**Application for an amendment to Development Consent  
DA10/0222 for Casuarina Town Centre including 56 lot  
subdivision, road works, infrastructure works and  
landscaping (Department of Planning Application MP06\_0258  
MOD 12) at Lot 13 DP 1014470; Casuarina Way CASUARINA;  
Lot 144 DP 1030322 & Lot 144 DP 1030322 & Lot 3 DP 1042119;  
Tweed Coast Road CASUARINA**

I refer to the above application for MP06\_0258 MOD 12 for Casuarina Town Centre  
and wish to advise that the below comments are provided:

**Figure 1 - Proposed Two Lot Subdivision**

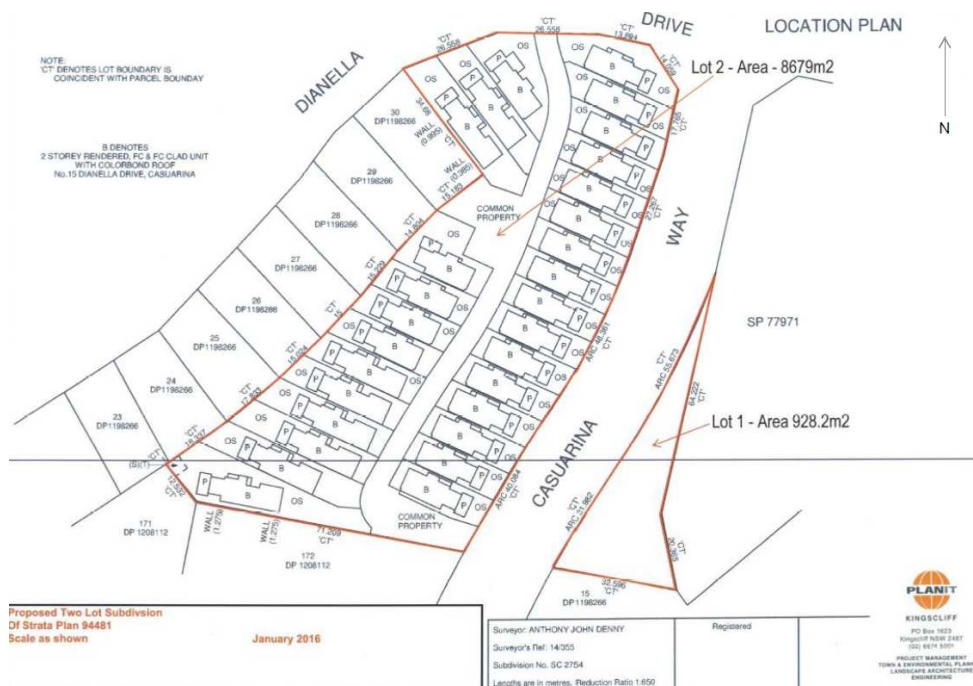
Proposed Lot 2 would retain connections to essential Council services such as water and sewer infrastructure, which presently service the residential units located on this land. However, it is not proposed to service proposed Lot 1 with any such services as part of this application.

However, the application if approved, would result in the creation of an approx. 928m<sup>2</sup> allotment which is zoned for residential purposes. In future, either the current landowner or a future landowner may wish to utilise the allotment for an alternate use to that currently identified, at which point the lack of services and the potential lack of ability to provide these services could constrain the site from being used for a use which is otherwise in accordance with the zone objectives for the area.

The modification report by the applicant (dated as amended 27 May 2019) requests that the provision of the above services not apply to this allotment until it is used for private occupation. In addition the report requests that a restriction be provided over the car parking Lot (referred to as Lot 1 in Figure 1 above).

The above request to not service a new Lot is not supported for the following reasons:

- Tweed Shire Councils Subdivision Manual – A5 specifies that all lots created in urban areas for private occupation must be fully and individually serviced.
- A restriction on title indicating that the lot is not serviced is not supported as this may potentially entrap buyers unaware of the current status quo.
- Not providing services as part of the two lot subdivision will create issues for future owners, potentially restricting development of the site as an independent parcel.
- Potentially can set a precedence for subdivisions to be created without the need to provide critical servicing infrastructure.

If applicant does not want to provide services then alternatively a boundary adjustment can be pursued rather than a separate Torrens title allotment. The modification report (amended 27 May 2019) specifies that the car parking lot (Proposed Lot 1 in Figure 1) is maintained as intended for the provision of car parking spaces for the lot 115 SP77871 being known as the Spice Den of Santai Resort. To be maintained as a car parking for lot 115 SP77871 Spice Den of Santai Resort then a boundary adjustment seems appropriate to be include as part of lot 115 SP77871. The boundary adjustment would ultimately enclose the car parking Lot (Lot 1 in figure 1) as part of the Spiced Den (Santi Resort), without the need to provide additional services as required for a Torrens title lot.

**Figure 2 - Proposed Sewer Layout**

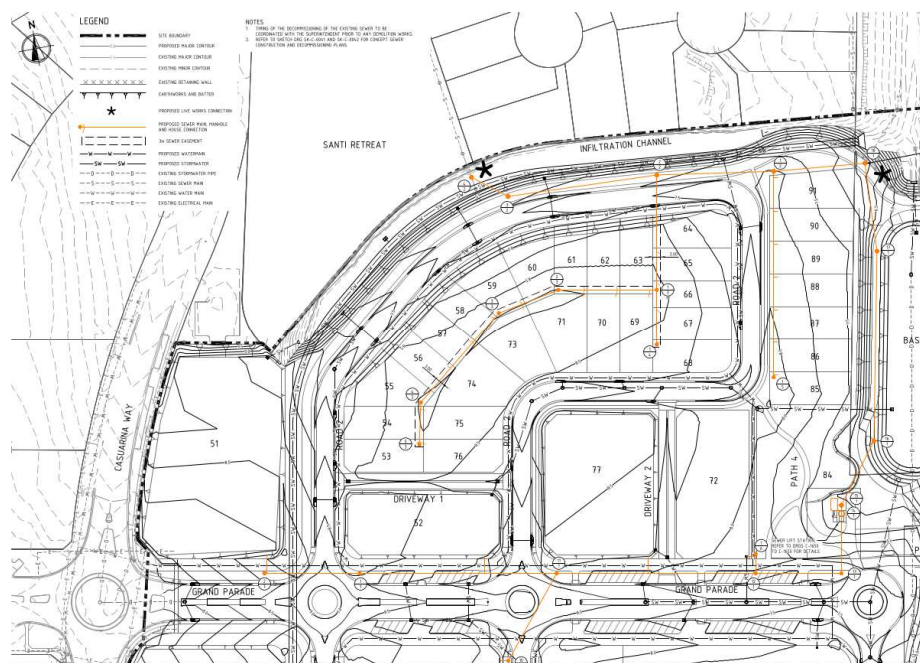
Council's piped effluent disposal infrastructure is available within the area, however it is not readily accessible for proposed Lot 1 as the sewer is located some distance away in the form of a sewer trunk main and a previous modification currently seeks to relocate this trunk main.

Given the proposal for a Torrens title lot (2 lot subdivision) it is recommended that the developer demonstrate how the site will be connected with sewer to the proposed Lot 1.

A construction Certificate (Reference CC18/0924) has been lodged with Council for an 89 Lot subdivision which seeks to divert an existing sewer trunk main as per below:

**Figure 3 – Extract from Engineering Assessment**

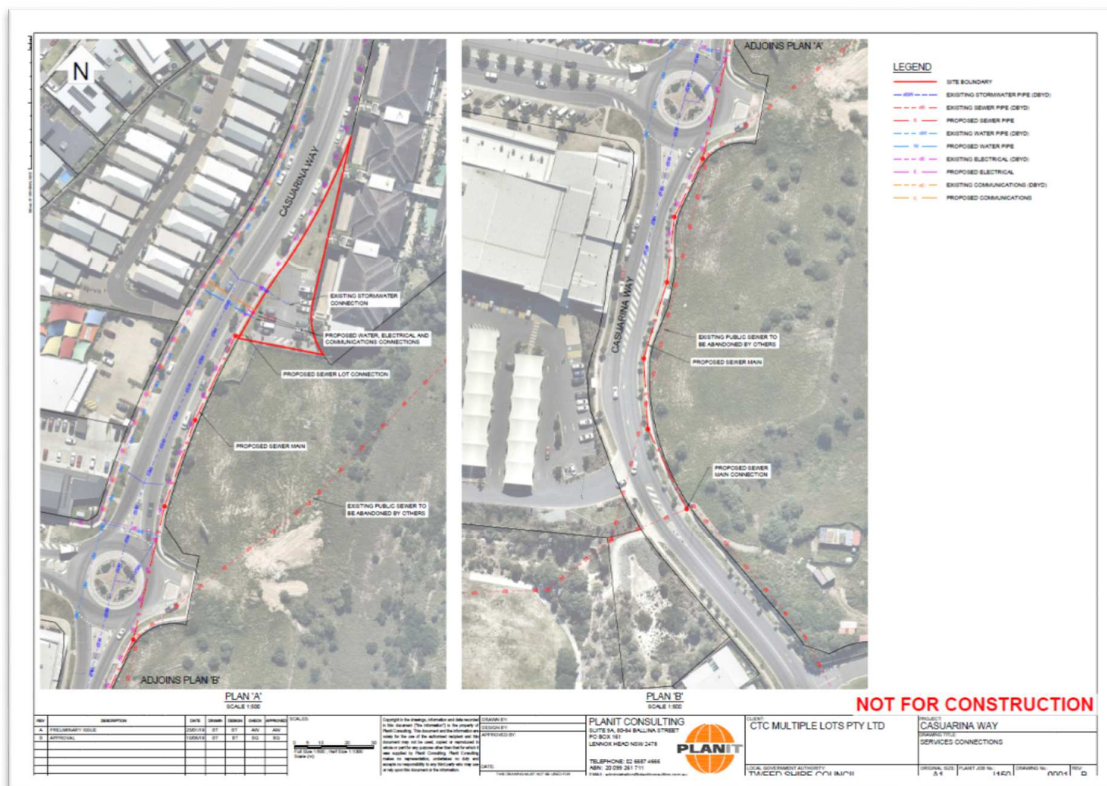
The applicant has provided an updated submission outlining how the existing car park lot could be serviced by sewerage if it were to be subdivided by Torrens Title. The applicant proposes that a long 260 meter sewer connection from the lot could be constructed along the Casuarina Way road reserve to the existing Council trunk sewer to the south. They have assumed that because the trunk sewer is so deep that they could get the fall required to install the sewer. However the developer has not taken into consideration many Council requirements such as:

1. The requirement to locate sewers within properties and not within road reserves, or
2. The future services that will shortly be constructed with Casuarina Way as a result of the large development to be constructed at Casuarina Town Centre on the adjacent block.

Council's Water & Wastewater Unit would not allow such a construction of the proposed single sewer to service this single lot. Therefore, Council's Water & Wastewater Unit do not believe that the applicant has demonstrated that the lot can be adequately serviced by sewer.
